**SUBJECT:** Corrective Measures Implementation Plan / Remedial Action Implementation Plan for the Early Construction and Operational Disposal Site N-1 (NBN), Central Shops Scrap Lumber Pile (631-2G), and Building 690-N, Process Heat Exchanger Repair Facility (aka Ford Building) Operable Unit (U) (SRNS-RP-2023-00535, Revision 1 Redline, January 2024), the Land Use Control Implementation Plan for the Early Construction and Operational Disposal Site N-1 (NBN), Central Shops Scrap Lumber Pile (631-2G), and Building 690-N, Process Heat Exchanger Repair Facility (aka Ford Building) Operable Unit (U) (SRNS-RP-2023-00536, Revision 1 Redline, January 2024), and Savannah River Site's Responses to the Regulatory Comments on the Revision 0 Documents, SEMS Number: 93

3. SRS Responses to USEPA Comments on the Corrective Measures Implementation Plan/ Remedial Action Implementation Plan for the Early Construction and Operational Disposal Site N-1 (NBN), Central Shops Scrap Lumber Pile (631-2G), and Building 690-N, Process Heat Exchanger Repair Facility (aka Ford Building) Operable Unit (U) (SRNS-RP-2023-00535, Revision 0, August 2023) SEMS Number: 93

4. SRS Responses to USEPA Comments on the La

**Figure 1. Location of the ECODS N-1, CSSLP, and Ford Building OU at the Savannah River Site**

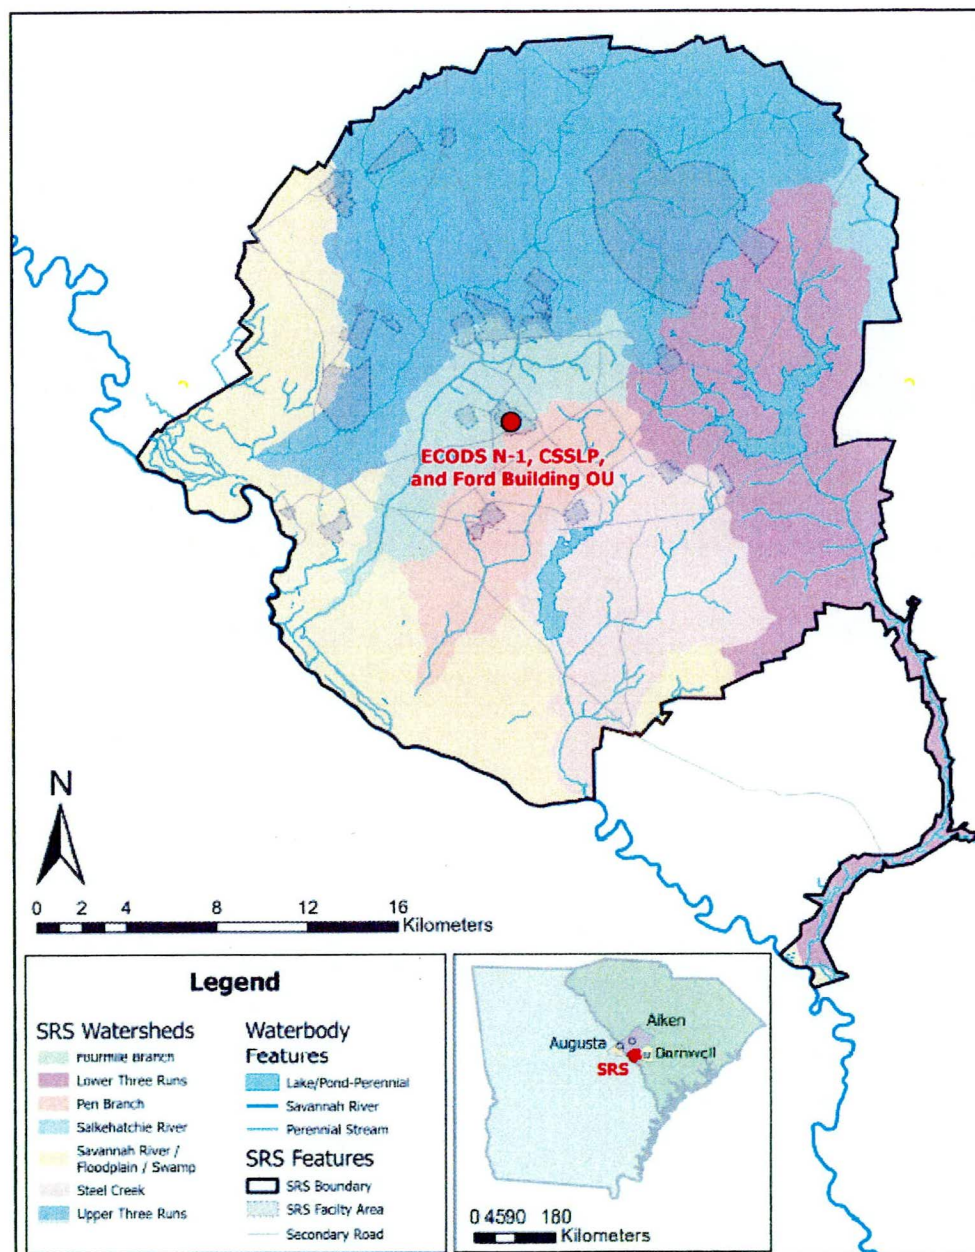
- 5. Figure 1, Location of the ECODS N-1, CSSLP, and Ford Building OU at the Savannah River Site, PDF Page 23:** The legend contains various entries denoted using colored polygons; however, it is unclear what each of these entries is representing as it is not described within the title of the figure, legend or in the text. The LUCIP indicates that Fourmile Branch and Pen Branch are watershed boundaries, but it is unclear whether all legend entries describe watershed boundaries. *Please revise the figure legend to clarify this information.*

**Response: Agree.**

**The legend in Figure 1 will be revised to denote the watershed boundaries as depicted by the colored polygons. The revised figure is attached at the end of this document.**

**Figure 2. Location of the ECODS N-1, CSSLP, and Ford Building OU (N Area)**

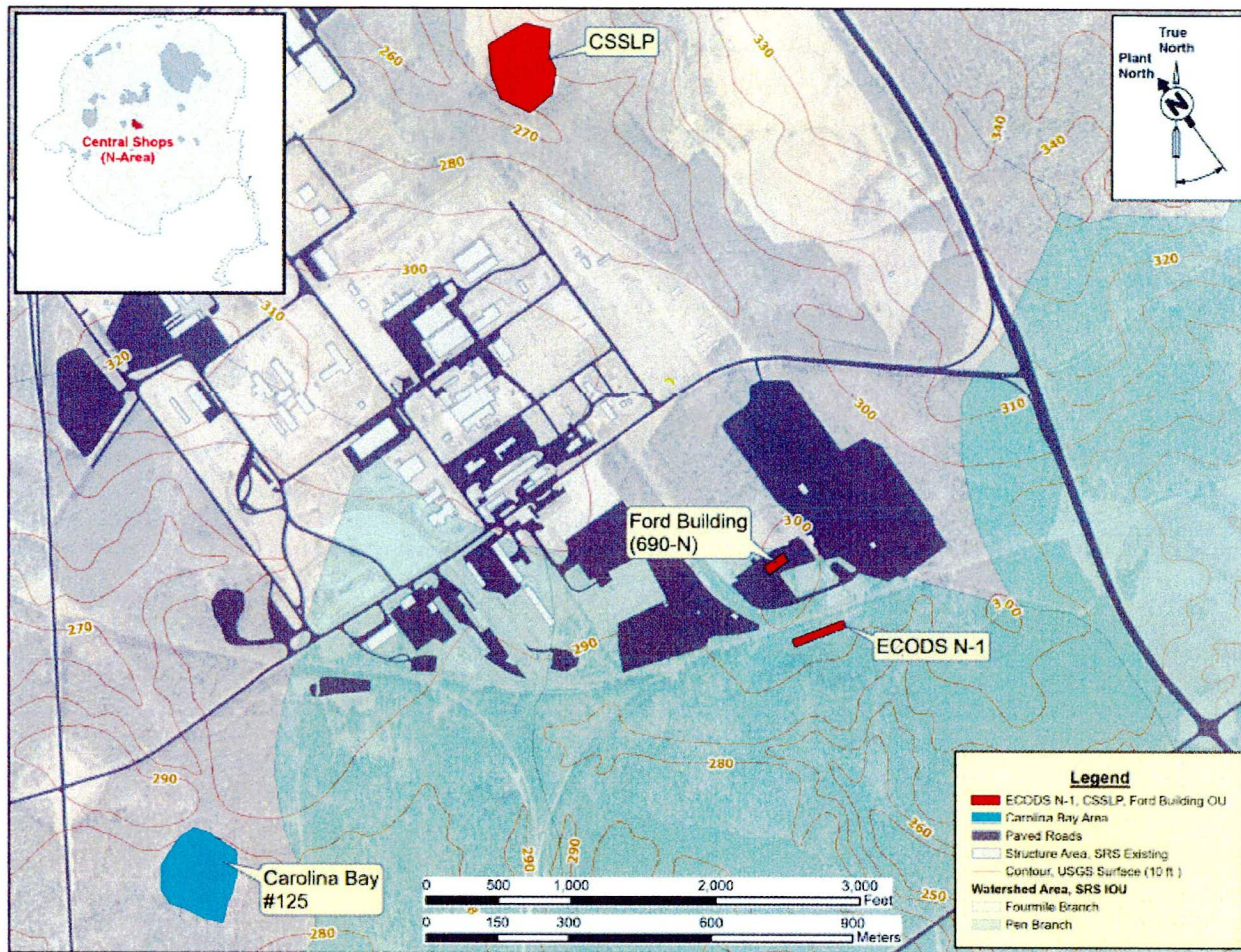
2. **Section 2.1, General Description and History of the ECODS N-1, CSSLP, and Ford Building OU, Page 2:** The text indicates the site area consists of relatively flat terrain and references Figure 2 (Location of the ECODS N-1, CSSLP, and Ford Building OU (N Area)); however, Figure 2 includes water table elevation contours and not ground surface elevation contours. Additionally, it is noted that groundwater is not included as part of the OU, and therefore, it is unclear why water table elevation contours are presented in absence of surface elevation contours. *Please revise Figure 2 to include ground surface elevation contours.*

**Response: Agree.**

Figure 2 will be revised to include topographic contours. The revised figure is attached at the end of this document.

**Figure 2. Location of the ECODS N-1, CSSLP, and Ford Building OU at the Savannah River Site**

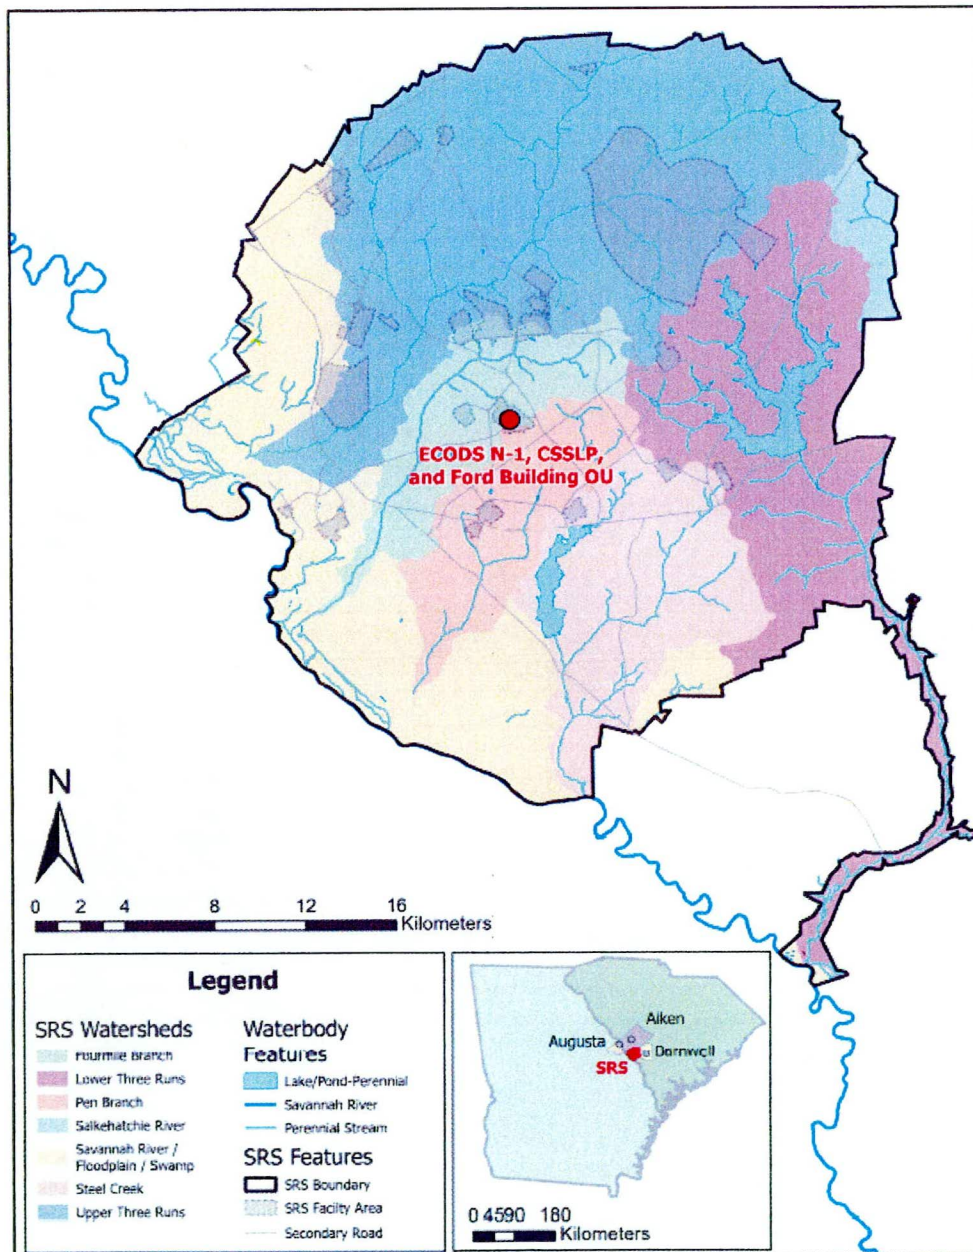
5. **Figure 2, Location of the ECODS N-1, CSSLP, and Ford Building OU at the Savannah River Site, PDF Page 30 and Appendix B, Figure B1, Location of N Area Within SRS, PDF Page 72:** The figures should clarify that watershed boundaries are depicted. The figures appear to be depicting various watershed boundaries at SRS; however, no explanation is provided in the title, legend, or as informational text. *Please revise the figures to indicate that watershed boundaries are depicted.*

**Response: Agree.**

**The legend in Figure 2 and Figure B1 will be revised to indicate the watershed boundaries as depicted by the colored polygons. The revised figures are included at the end of this document.**

**Figure 5. CSSLP Subunit Hotspot Removal Locations**

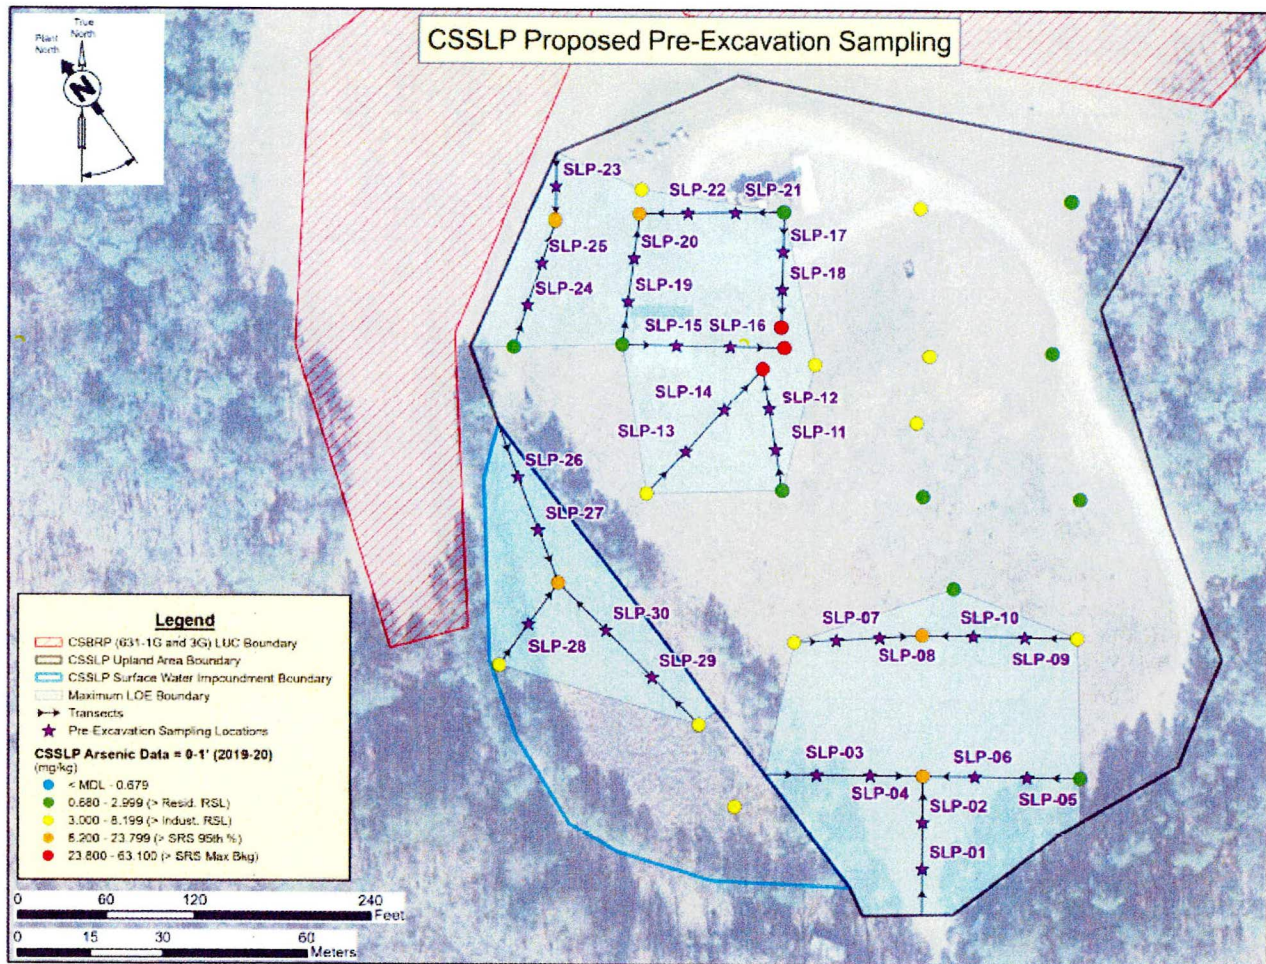
7. **Appendix B, Sampling and Analysis Plan (SAP) for Pre-Excavation for the ECODS N-1, CSSLP, and Ford Building OU, PDF Page 75:** It is unclear why the SAP does not use consistent units of measurement. For example, previous sampling results are presented on Figures B3 and B4 in micrograms per kilogram (ug/kg); however, the remainder of the SAP uses milligrams per kilogram (mg/kg). *For clarity, please revise the SAP to use consistent units of measurement.*

Figures B3 and B4 will be revised to include concentrations in mg/kg. Figure 5, CSSLP Subunit Hotspot Removal Locations, within the CMIP/RAIP portion of the document will also be revised to include the consistent units. The revised figures are included at the end of this document.

**Figure B4. Pre-Excavation Sampling Locations to Refine the LOE**

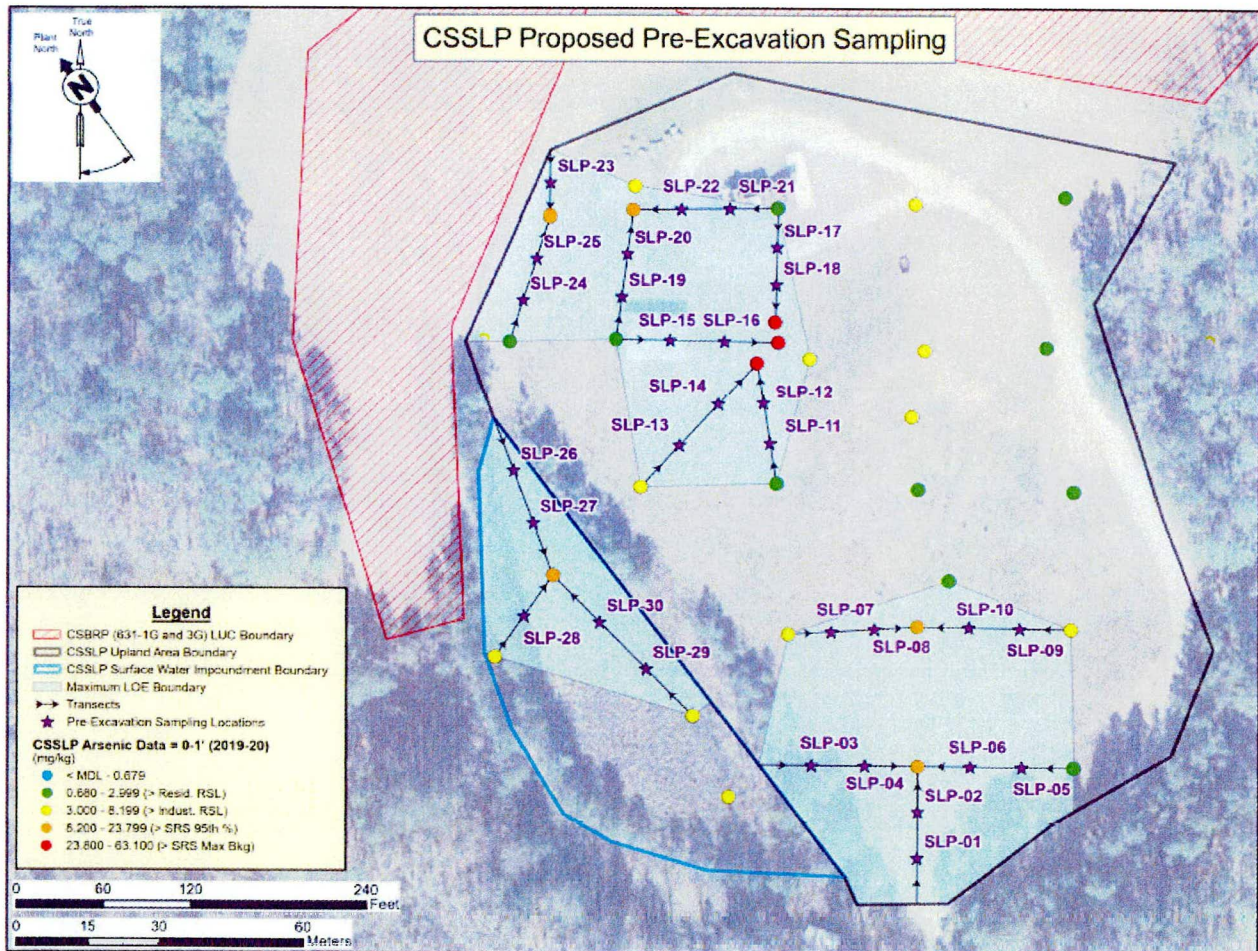
- 9. Appendix B, Sampling and Analysis Plan (SAP) for Pre-Excavation for the ECODS N-1, CSSLP, and Ford Building OU, Figure B4, Pre-Excavation Sampling Locations to Refine the LOE, PDF Page 75:** The figure should include the arsenic result for each historical soil location that provides the basis for the proposed sampling locations. Additionally, the figure should label each proposed sample location with the sample identification and the legend should be revised accordingly for accuracy. *Please revise the figure to include the requested changes.*

**Response: Agree with Clarification.**

**The legend indicates the range of arsenic concentrations at the historical soil locations. This range defines which location are above or below the cleanup level (e.g., SRS background 95<sup>th</sup> %tile). The cleanup level is the basis for the proposed sampling locations; therefore, including the individual concentrations of each historical sample is not needed to refine the LOE. Figure B4 will be updated to include labels for the proposed sample locations. Figure 5, CSSLP Subunit Hotspot Removal Locations, within the CMIP/RAIP portion of the document will also be revised to include the proposed sample location labels. The revised figures are included at the end of this document.**
